**Town of Kittery  
Planning Board Meeting  
February 22, 2024**

**ITEM 2—283 US Route 1—Master Site Plan — Final Review**

**PROCESS SUMMARY**

MARK	DATE	DESCRIPTION
A	1/25/2024	Site Plan Review
PROJECT NO: T5037-003		
DATE: 1/25/2024		
FILE: T5037-003_C-DESIGN.DWG		
DRAWN BY: CML		
CHECKED: NAH		
APPROVED: PMC		
PHASE 1 - GRADING, DRAINAGE & EROSION CONTROL PLAN		
SCALE: AS SHOWN		
<b>C-103.1</b>

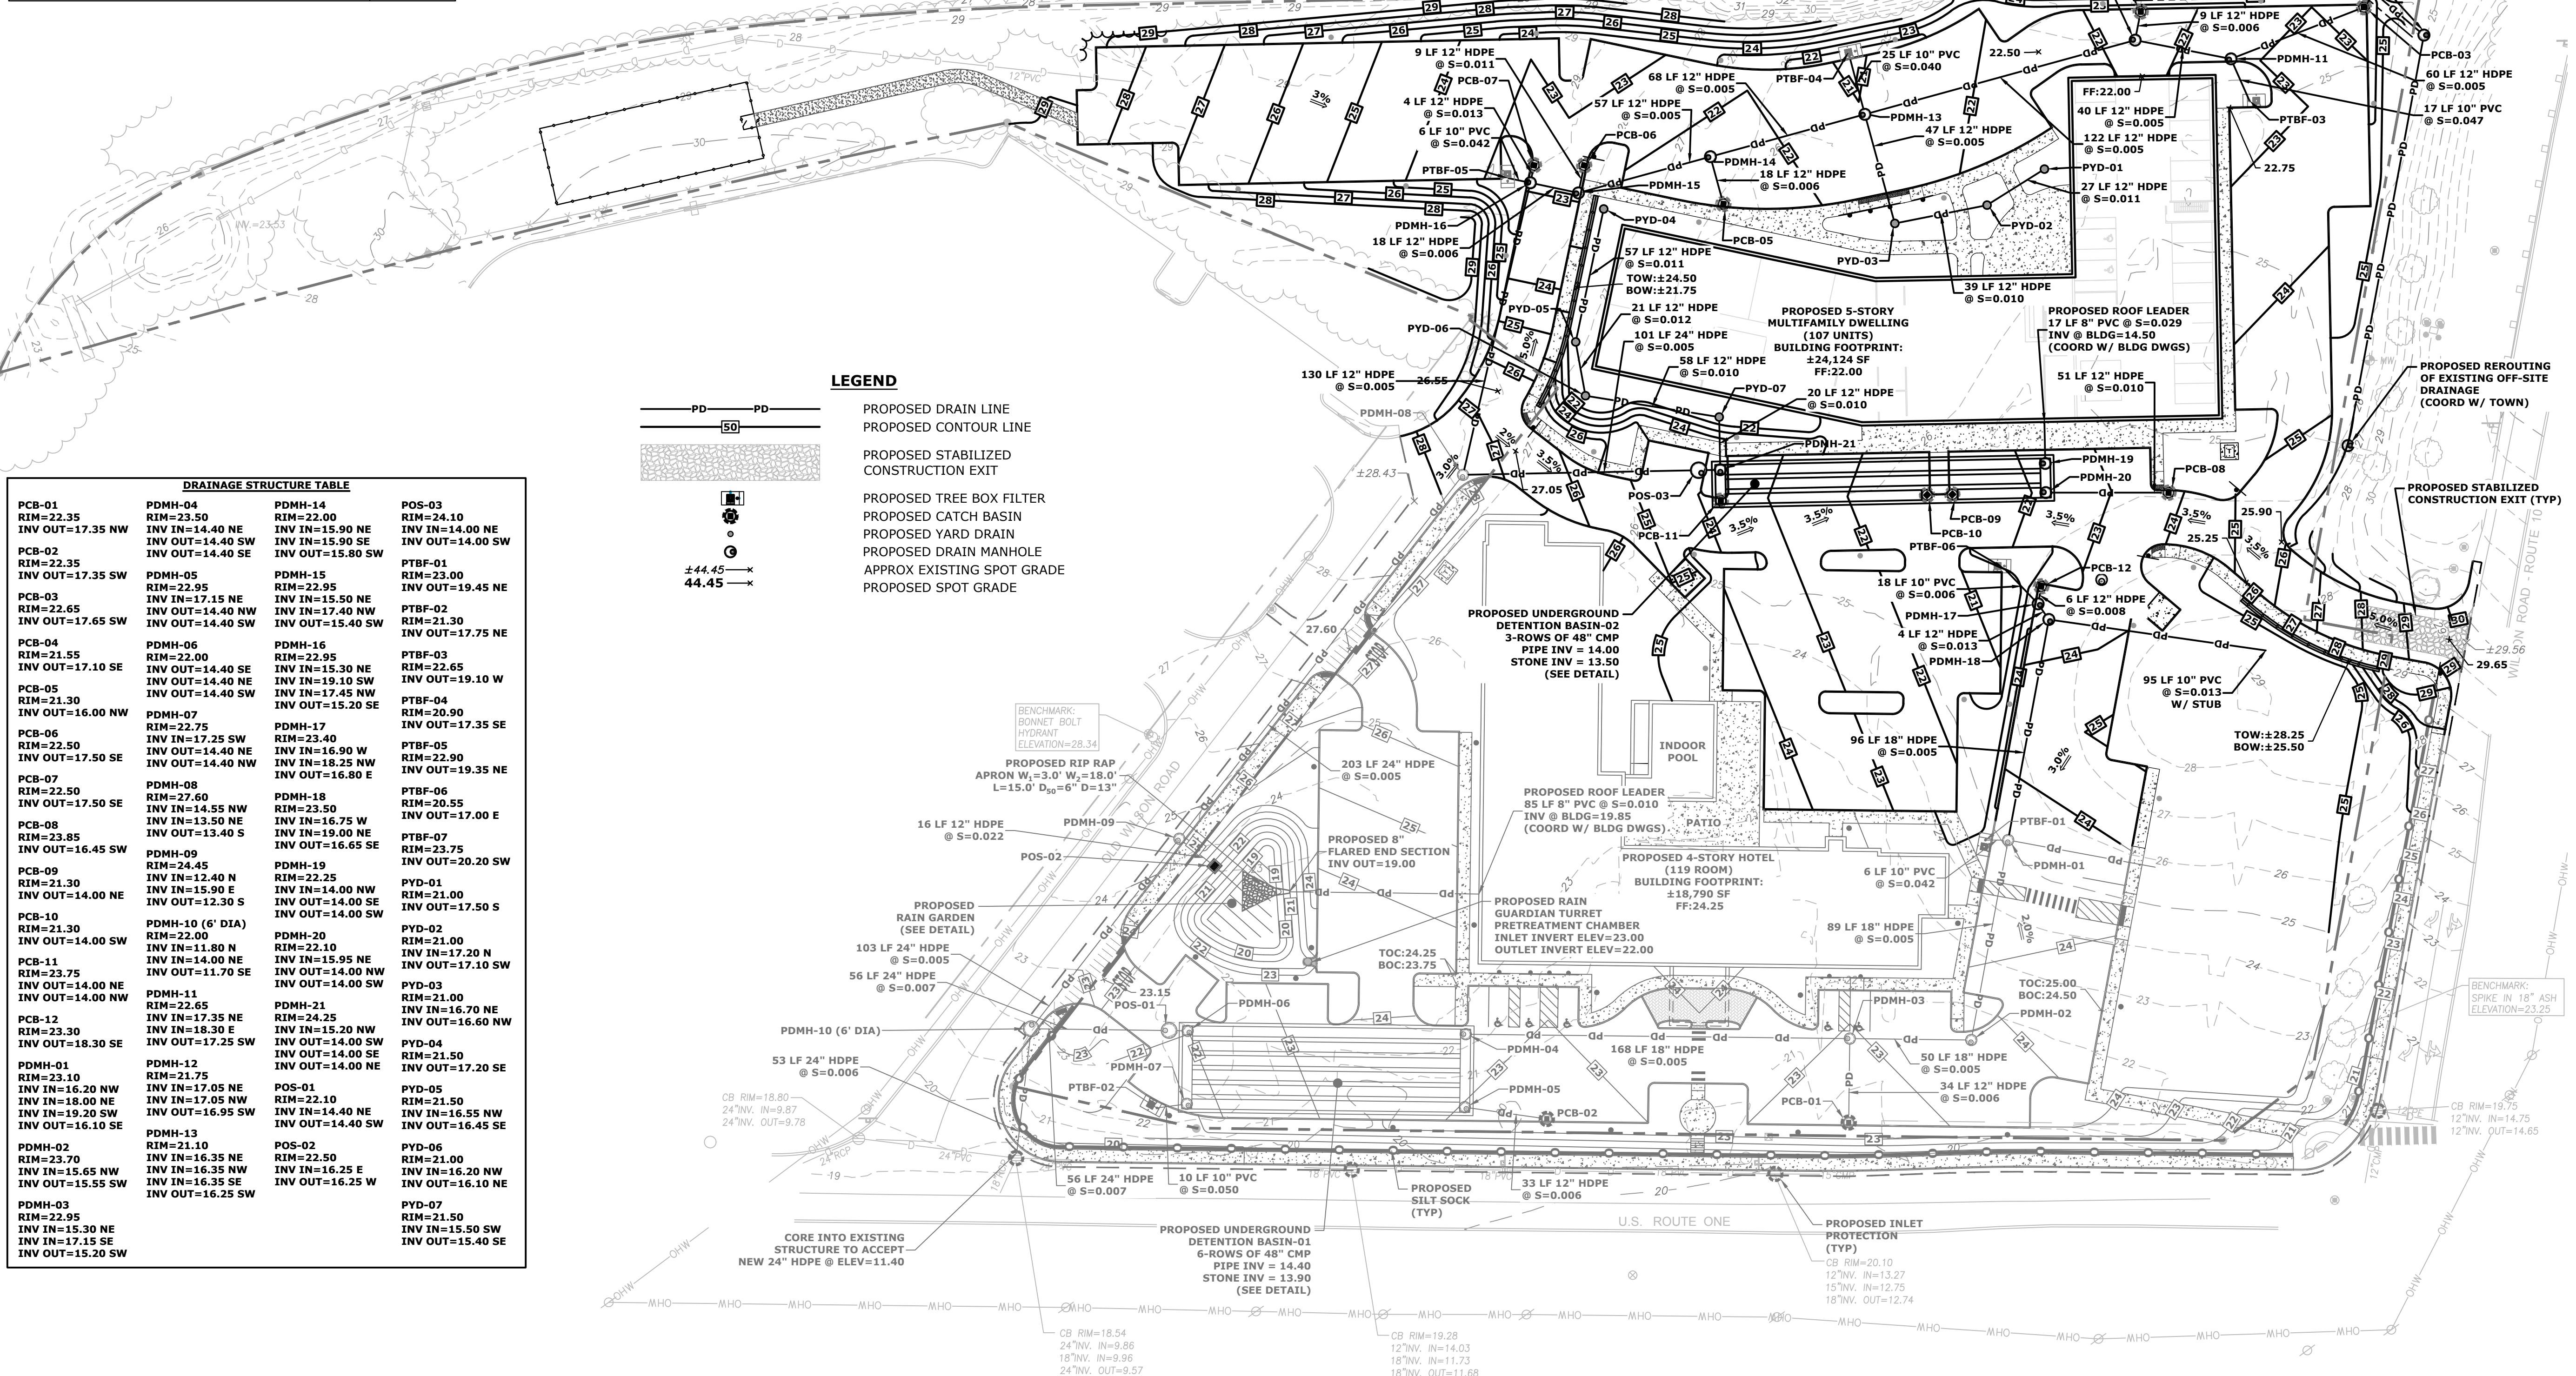
1. The impervious areas on Sheet C-102 (186,910 SF) and Sheet C-103 (191,183 SF) do not match.

1. The impervious cover does not match the quantity on Sheet C-102.
2. Erosion Control Notes 1 and 8 are similar.
